Access Compliance Report Public Rights-of-Way (Curb Ramps)

Main Street: SENDERO_WAY Cross Street: FUTURO_ST Location: S

ADA ID: RPRK211116140817 Ramp Type: Type 1 - Perpendicular Initial Pass/Fail: Pass Overall Compliance: No Severity Score: 25

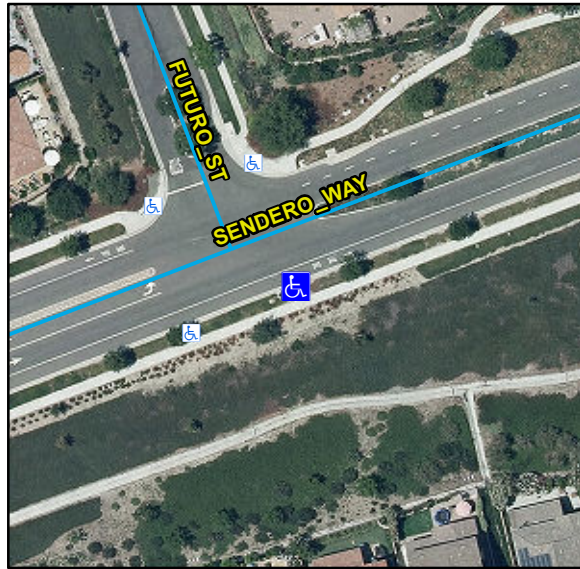
R304.2.2, R304.5.3, R304.5.4, STD 1115

Compliance	Description	Data	Compliance	Description	Data
N/A	Ramp Length (in)	90	N/A	Flare Type LT	
Yes	Ramp Width (in)	60			Sloped
Yes	Ramp Run Slope (%)	7.9	N/A	Flare Slope LT (%)	19.2
No	Ramp Cross Slope (%)	7	N/A	Flare Traversable LT	No
N/A	Landing Present	Yes	N/A	Flare Type RT	
N/A	Landing Length (in)	61			Sloped
Yes	Landing Width (in)	60	N/A	Flare Slope RT (%)	1.5
Yes	Landing Run Slope (%)	0.3	N/A	Flare Traversable RT	No
No	Landing Cross Slope (%)	7.3	Yes	DWS Provided	Yes
N/A	Landing Movement Obstructed?	No	Yes	DWS Contrast	Yes
	Landing Movement Type	N/A	Yes	DWS Length (in)	36
N/A	Landing Shared	No	Yes	DWS Full Width	Yes
N/A	Clear Space	N/A	Yes	DWS Offset Left (in)	0
N/A	Clear Space To Crosswalk (in)	N/A	Yes	DWS Offset Right (in)	N/A
N/A	Marked Crosswalk 1	No	N/A	Marked Crosswalk 2	N/A
	Crossing 1 Direction	N		Crossing 2 Direction	N/A
	Marked Crosswalk 1 Width (in)	N/A		Marked Crosswalk 2 Width (in)	N/A

N/A	Ramp Inside Crosswalk 1	N/A	Yes	Ramp Inside Crosswalk 2	N/A
	Crossing 1 Slope (%)	3.2		Crossing 2 Slope (%)	N/A
	Crossing 1 Cross Slope (%)	8		Crossing 2 Cross Slope (%)	N/A
Yes	Gutter Ponding	No	No	Curb Slope	5.9
Yes	Gutter Lip Height (in)	0		Road Run Slope (%)	N/A
No	Gutter Run Slope (%)	13.8		Road Cross Slope (%)	N/A
No	Gutter Cross Slope (%)	7.5			
Yes	Overall Surface Condition: Acceptable		Yes	Perp Joint Present	Yes
	Cross Gutter Present?	No		Spandrel Present?	No
	Replace Cross Gutter?	N/A		Replace Spandrel?	N/A

Remove & Replace Entire Ramp. Remove & Replace Gutter.
